COMMERCIAL ENGINE
BULLETIN

ENGINE, POWER AND ACCESSORY GEARBOX COVER ASSEMBLY
TURBINE SUPPORT STUDS - REPLACE

CEB 72-2024
CEB 72-3017
CEB 72-5056
CEB 72-6065

Gearbox Cover Assembly
FIG. 1

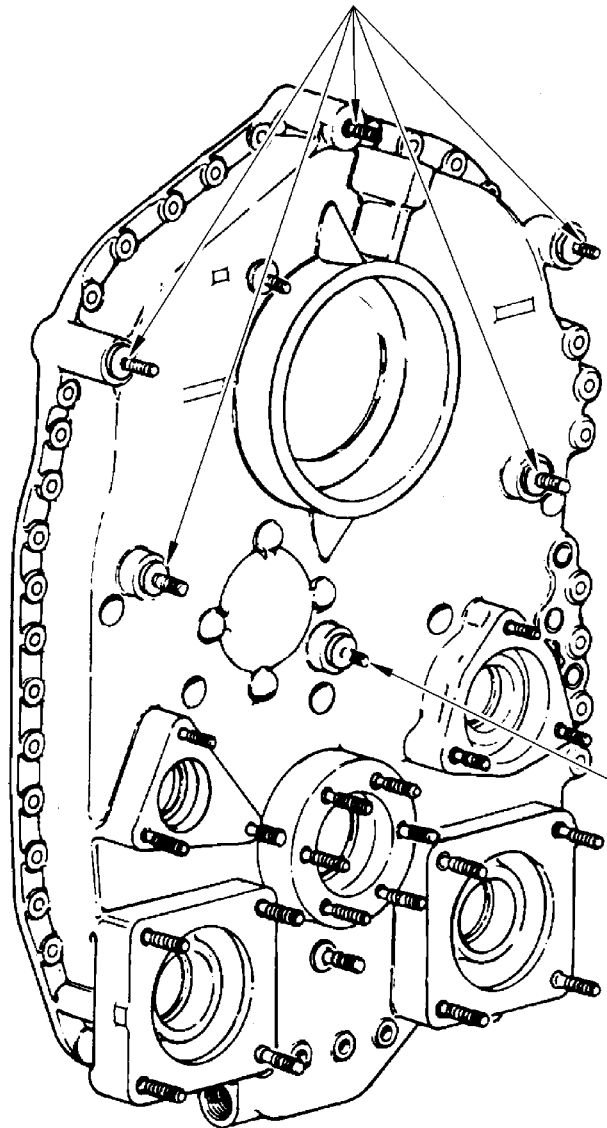
- A. Modify and reidentify P/N 6895079 Gearbox Cover Assembly into P/N 23001930 Cover Assembly (Ref. Figures 1, 2, and 3).
- B. Make sure that the cover assembly to be modified has passed the inspection criteria and condition requirements in the appropriate Overhaul Manual.
- C. Comply with procedures in the appropriate Overhaul Manual.
- D. Remove the six P/N 6841729-021 Turbine Mounting Studs.
- E. Machine the face of each of the stud bosses to a new height dimension of 1.788-1.792 in. (45.42-45.52 mm) (Ref. Figure 3).
- F. Make sure that the flanges of the five new P/N 23001928-0 and one new P/N 23001929-1 Studs comply with the dimensional limits (Ref. Figure 4).

P/N 23001928-0 SHOULDERED
STUD IN 5 LOCATIONS MARKED **EQ**

P/N 23001929-1 SHOULDERED
STUD LOCATION MARKED **ER**

Gearbox Cover Assembly
FIG. 2

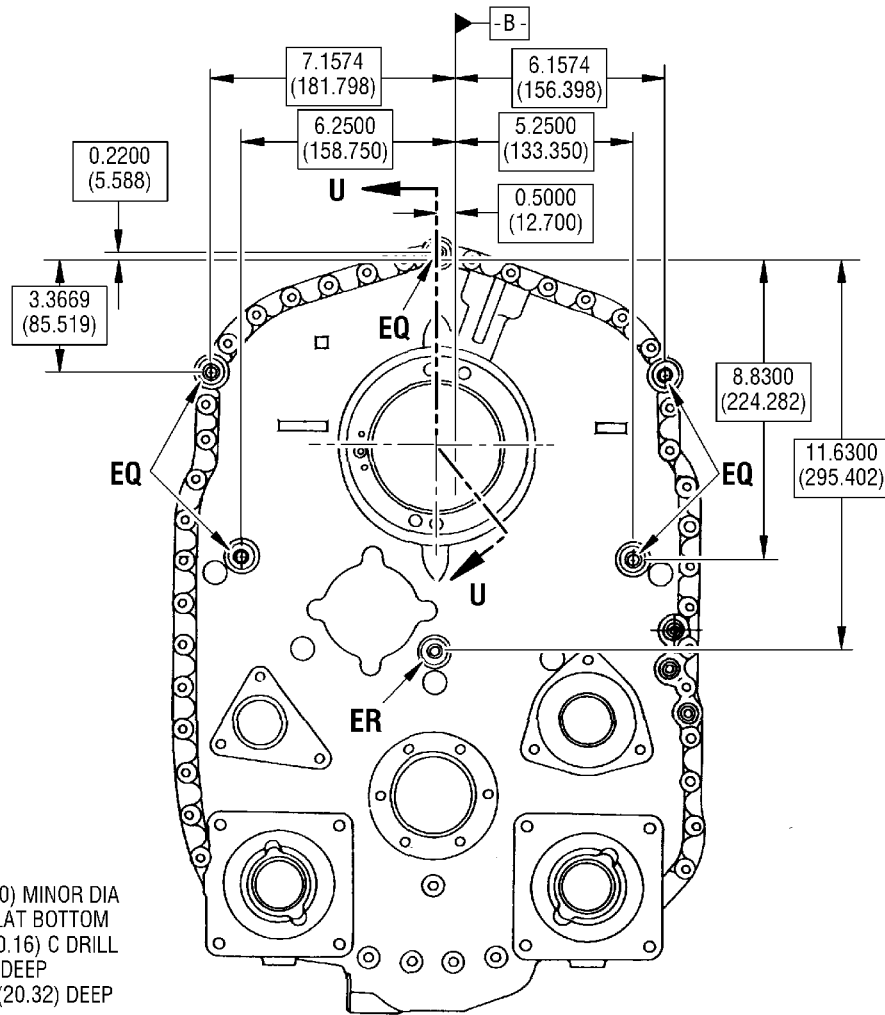
- G. Drill and tap the upper five stud bosses, counter-drill the lower middle stud boss, and install five new P/N 23001928-0 Studs and one new P/N 23001929-1 Stud (Ref. Figures 2 & 3).

- (g) Wipe off excess adhesive.
- H. Counter-drill the lower middle stud boss to a diameter of 0.390–0.400 in. (9.91–10.16 mm) by a depth of 0.060 ± 0.010 in. (1.52 ± 0.25 mm). Install one new P/N 23001929-1 Shouldered Stud (Ref. Figure 2).

0.3142-0.3251 (7.980-8.260) MINOR DIA
1.030 (26.16) MAX DEEP FLAT BOTTOM
DRILL 0.390-0.400 (9.91-10.16) C DRILL
0.060±0.010 (1.52±0.25) DEEP
0.3750-16 UNJC-3B 0.800 (20.32) DEEP
1 PLACE MARKED **ER**

0.4251-0.4368 (10.798-11.095) MINOR DIA
1.030 (26.16) MAX DEEP FLAT BOTTOM
DRILL 0.510-0.520 (12.95-12.21) C DRILL
0.060±0.010 (1.52±0.25) DEEP
0.5000-13 UNJC-3B 0.800±0.010
(20.32±0.25) DEEP
5 PLACE MARKED **EQ**

Typical Cross Sectional View for Five (5) Studs (EQ) and One Stud (ER)
 FIG. 3

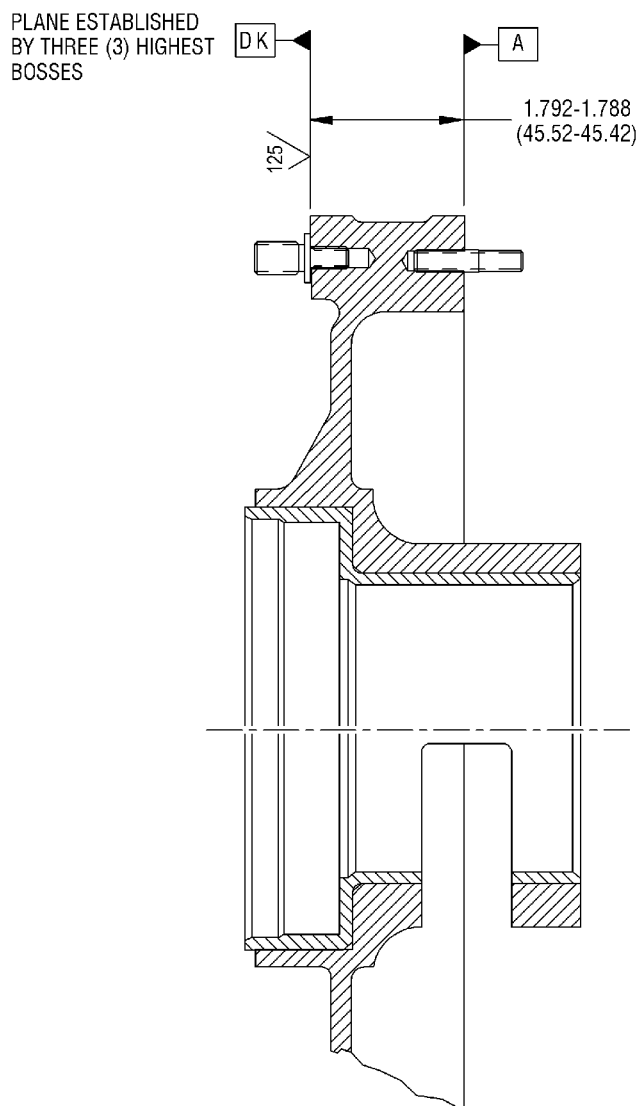
- (e) Select stud size by trial fit using the smallest size first. Use progressively larger sizes until the required stud driving torque is achieved.
 - (f) Stop applying driving torque as soon as stud flange contacts Surface DK (Ref. Figure 3). Flange must be in contact and flat against boss. Excessive driving could cause the flange to cone up.

- (2) Make sure that each stud is perpendicular to Surface A (Ref. Figure 3).
- I. Cure adhesive by heating the Gearbox Cover Assembly to 250° F (121° C) for one hour.
